**Plexus Scientific Corporation**

**Re: Current Lighting Solutions, LLC Responses to NRC's RAI dated November 14, 2019  
– USNRC Mail Control Number 616865**

**ATTACHMENT 2**

# Samples of GE Lamps Containing Kr-85 & Thorium

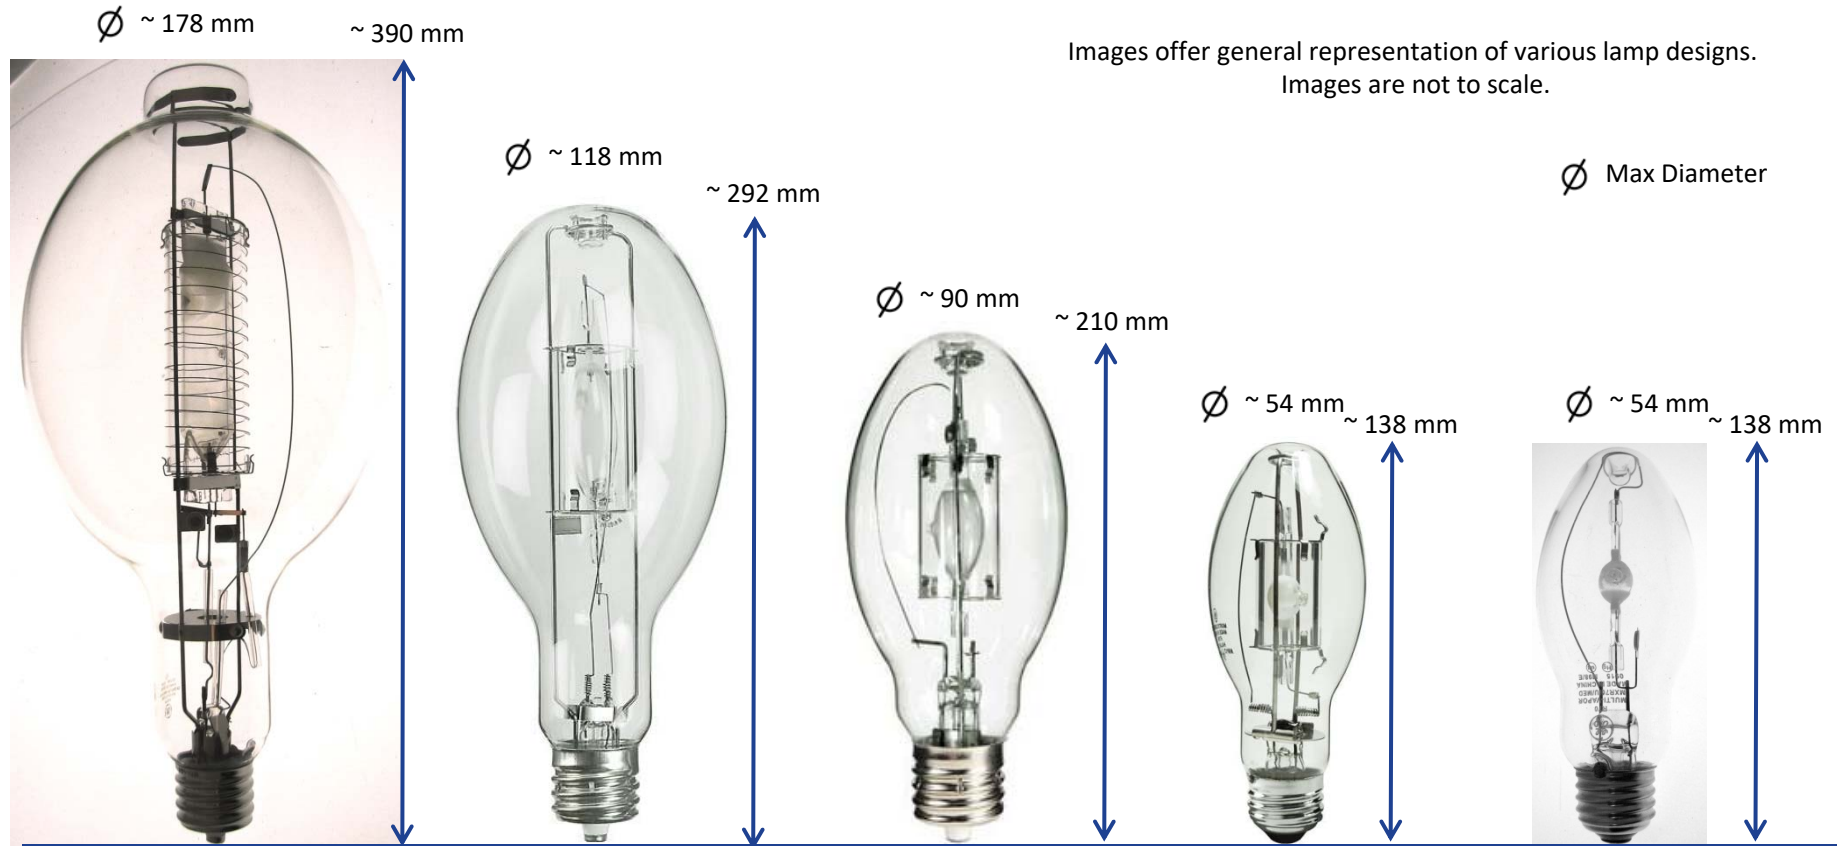
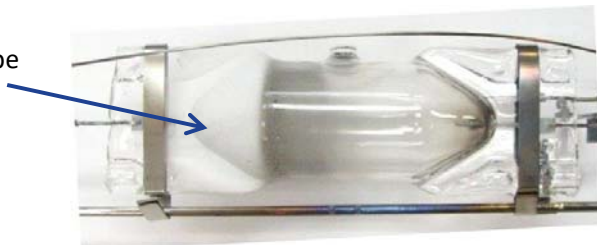
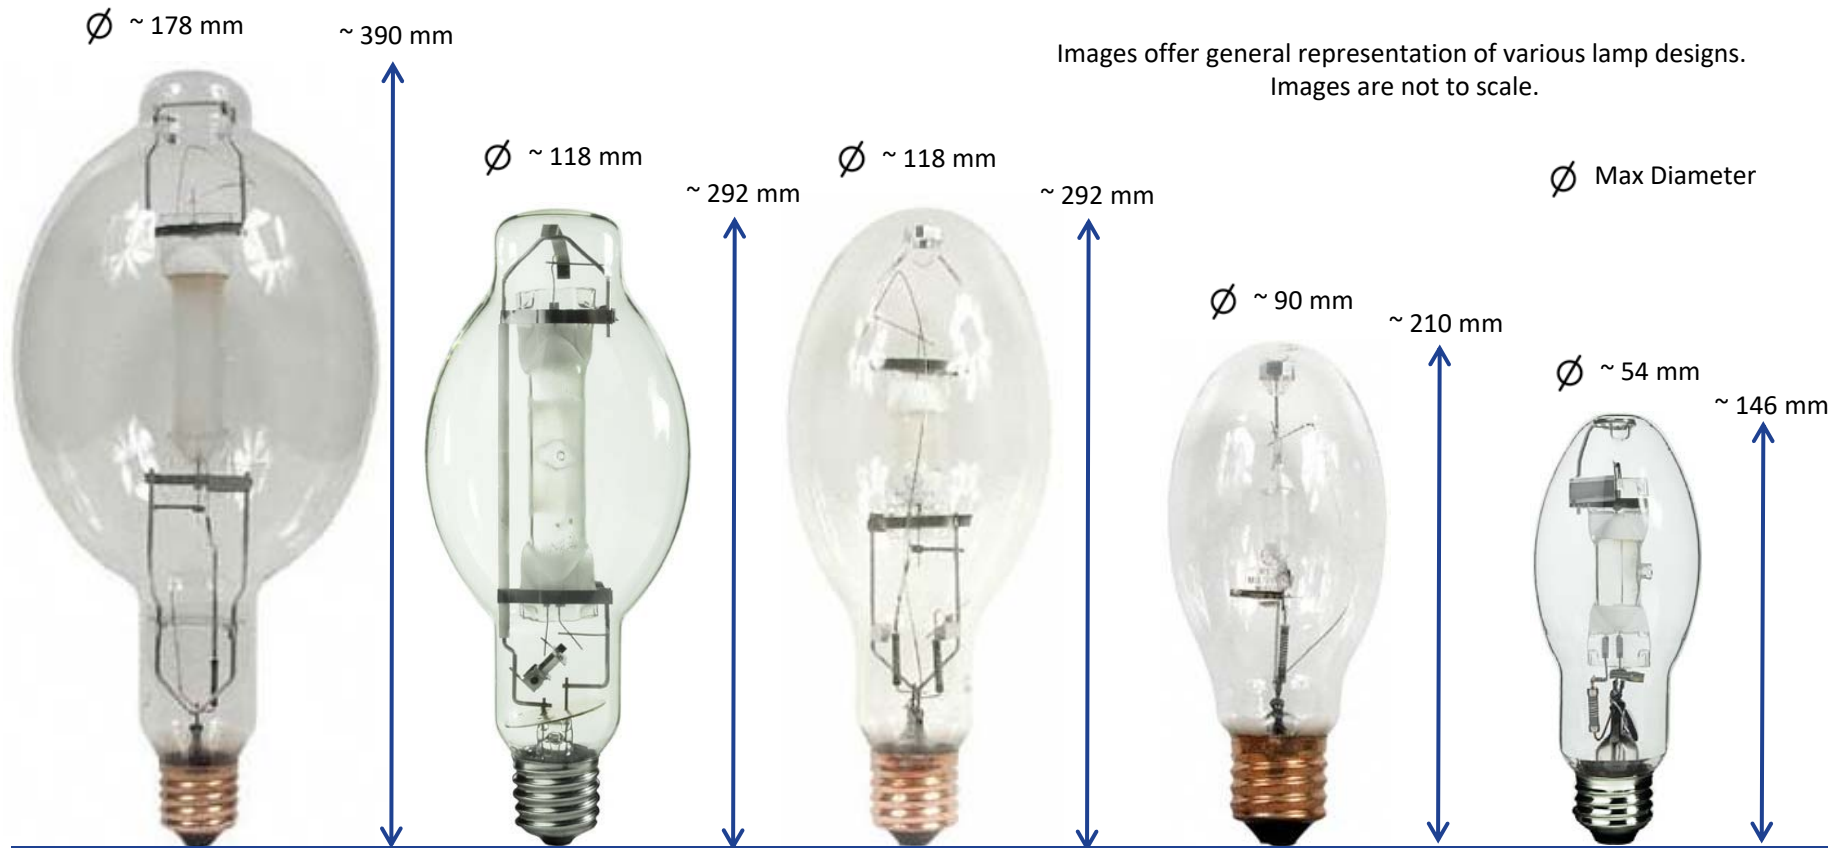
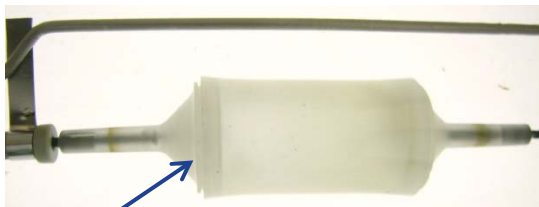
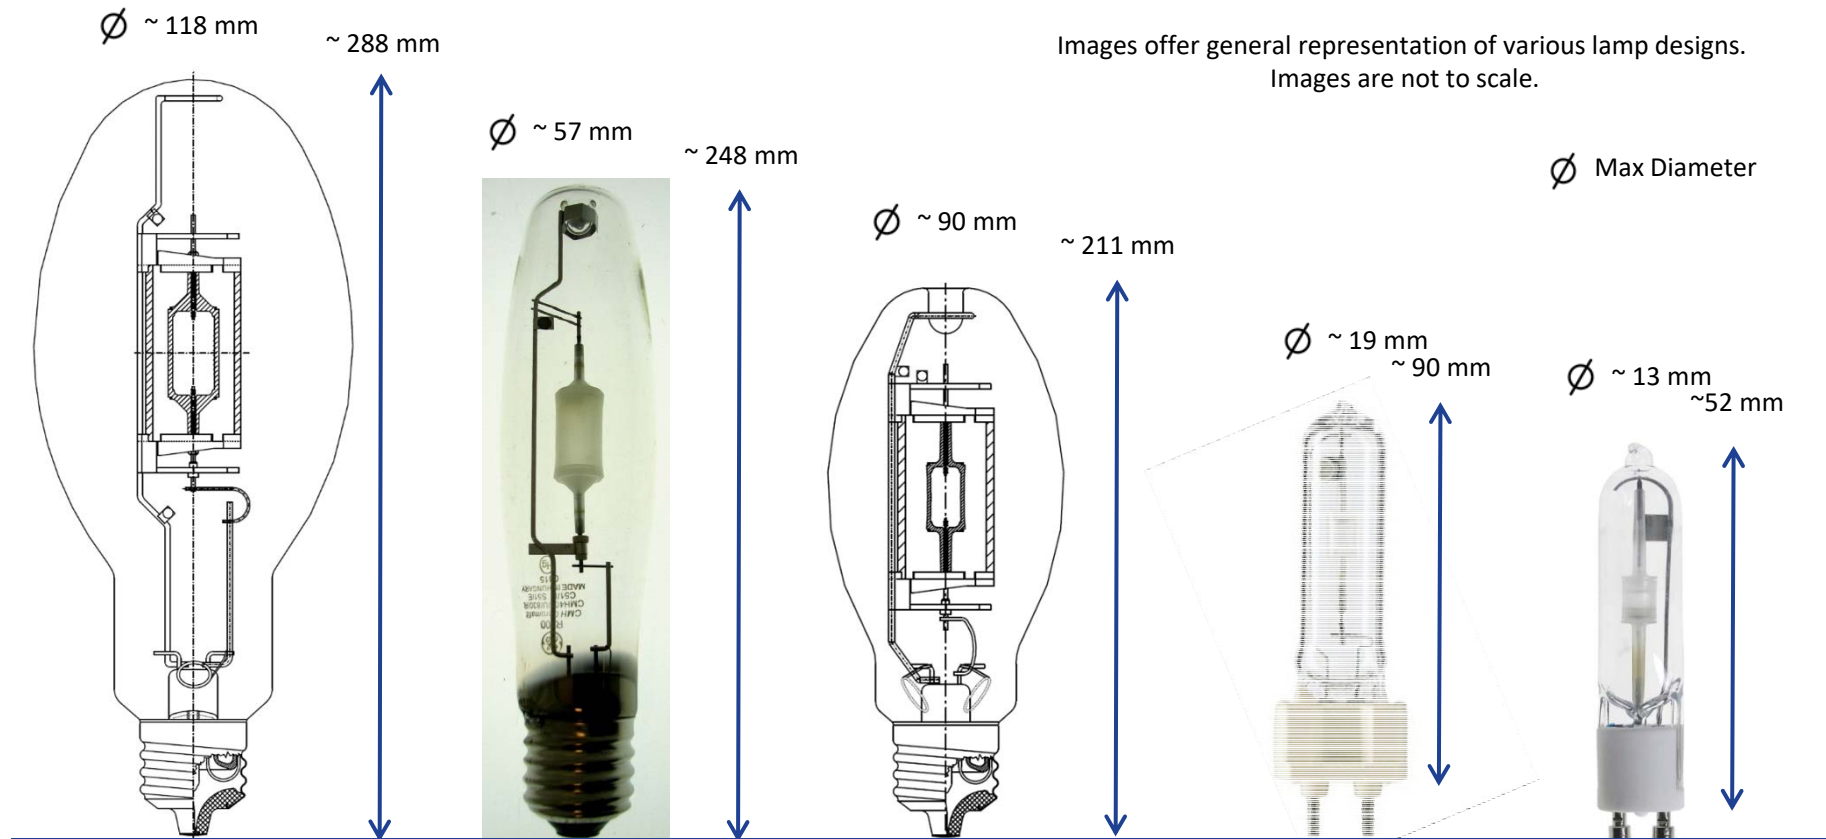
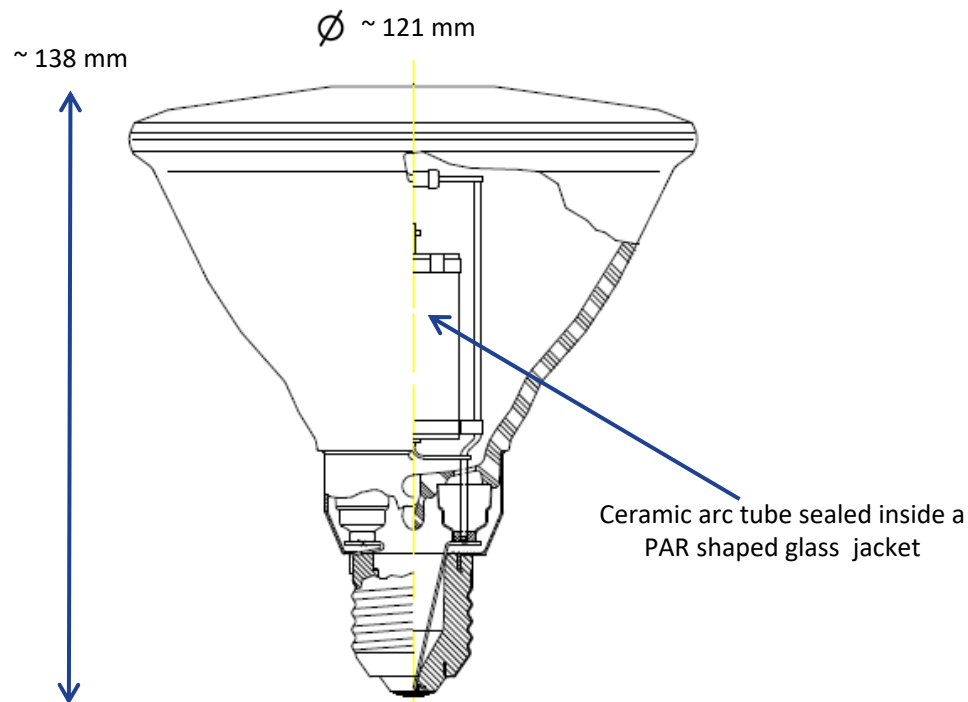
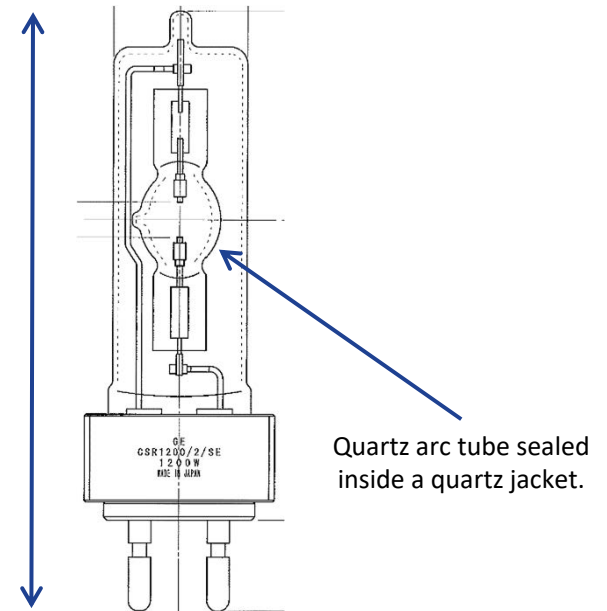
6. *10 CFR 40.52(b)(2) requires the applicant to submit details of construction and design of each product. Please resubmit this information in your revised application to take into account the inclusion of thorium. Please provide descriptive text of the construction and design of each product.*

Response: Small amounts of thorium are hermetically sealed within a quartz arc tube, and the arc tube is mechanically secured and further hermetically sealed within a second outer glass or quartz bulb. Industry proven manufacturing techniques that have been in existence for 40-50 years or longer maintain the thorium within the lamp and prevent release under normal transport and operating conditions. Attachment 2 contains an example schematic which shows the locations of the thorium inside the lamp.

Kr-85 gas and thorium alloyed with tungsten cathodes are contained within a hermetically sealed quartz arc tube.  
The arc tube is also hermetically sealed inside a glass or quartz outer bulb.

Thorium oxide alloyed with tungsten electrodes are contained within a hermetically sealed quartz arc tube

Kr-85 is contained within a hermetically sealed ceramic arc tube.  
The arc tube is also hermetically sealed inside a glass or quartz outer bulb.

# Samples of Kr-85 Lamp & Package Labeling

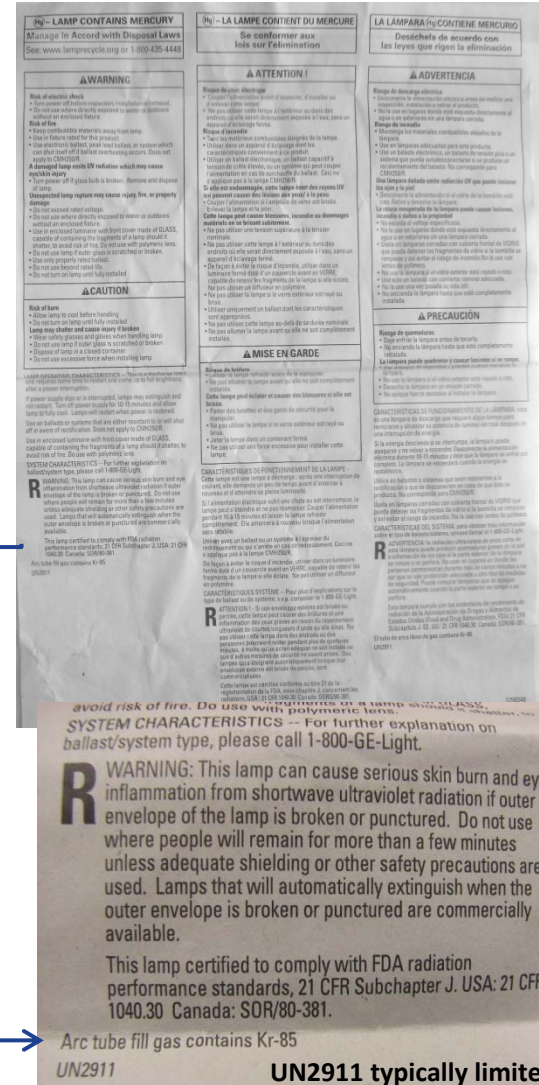
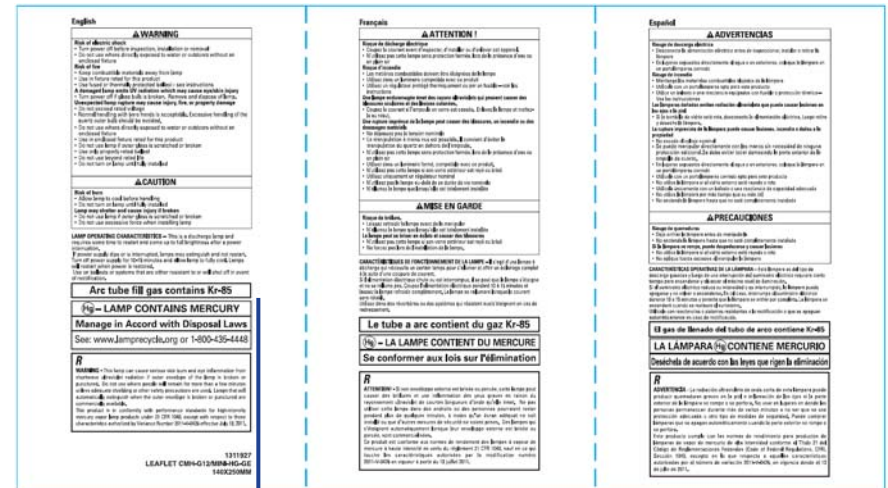
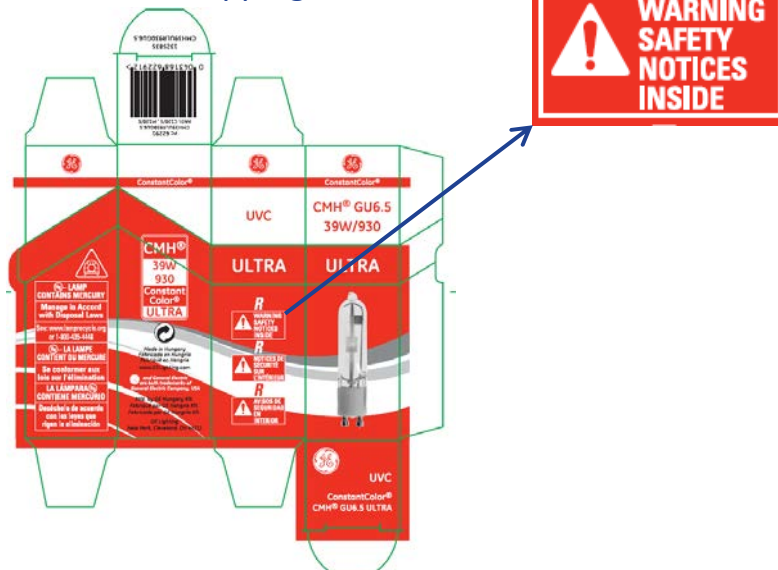
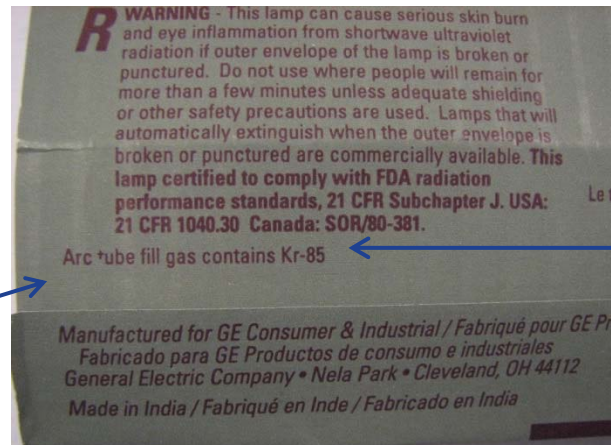
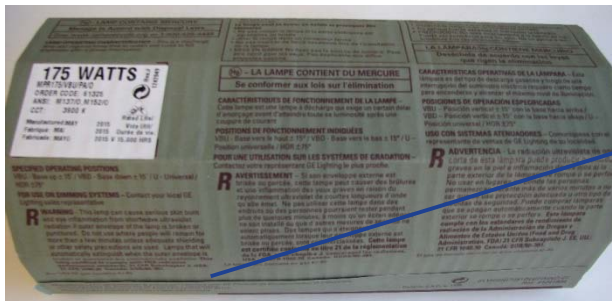
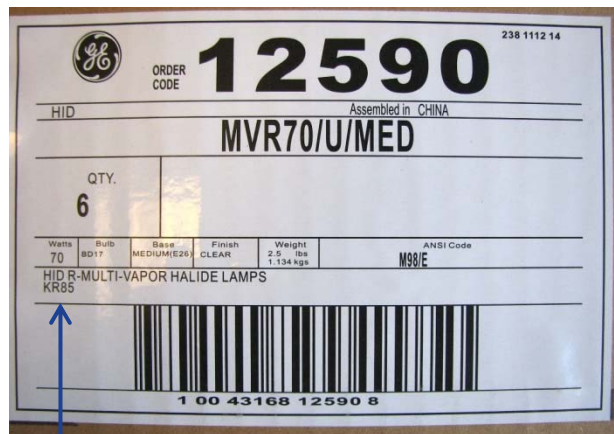
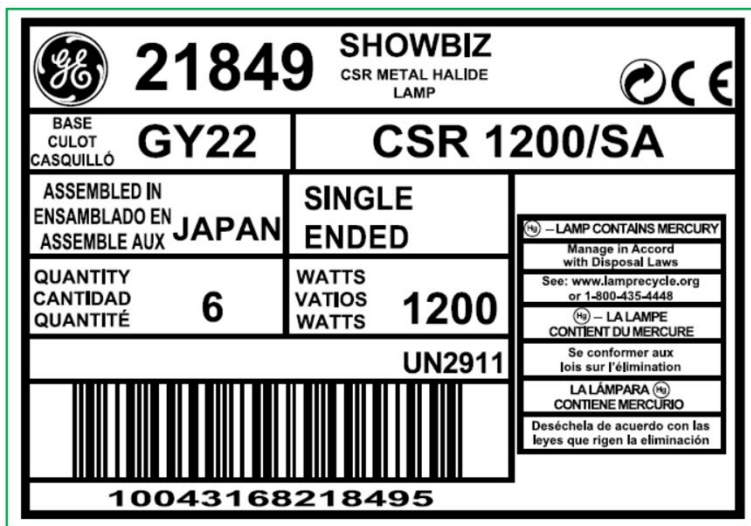
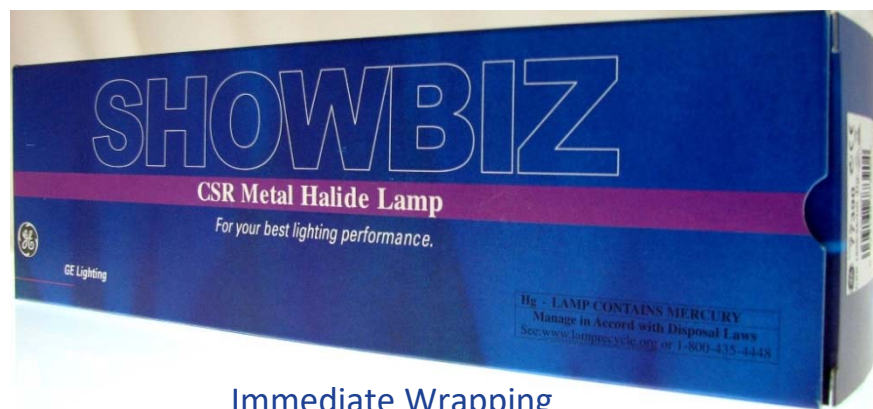
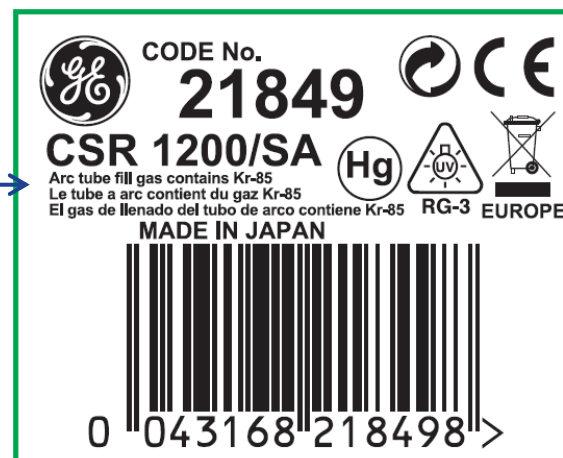
8. *10 CFR 40.52(b)(4) requires the applicant to submit the proposed method of labeling or marking each unit, and/or its container with the identification of the manufacturer or initial transferor of the product and the source material in the product. Please provide copies of the labels that will be used on each type of product (or container where the product is too small to be labeled) that contains thorium.*

Response: Existing lamps that have ample surface area and/or possess the type of surface that can be feasibly marked and/or containers that are marked only contain “Kr-85” in the warning label as presented in our license application submittal. GE and Current are not aware that our competitors/other suppliers include “thorium” in their labels. GE will have to arrange to have “thorium” added to the marking/labeling for applicable lamps unless the NRC is willing to agree that the Kr-85 marking and product cycle instruction that is provided to general licensees (refer to Attachment 2) is acceptable and ensures adequate product safety. Product cycle instruction for lamps with Kr-85 are considered adequate for the lamp products that contain unimportant quantities of thorium. It is also noted that to retroactively change labeling for product in facility inventories will have an unacceptable, negative impact on the business.
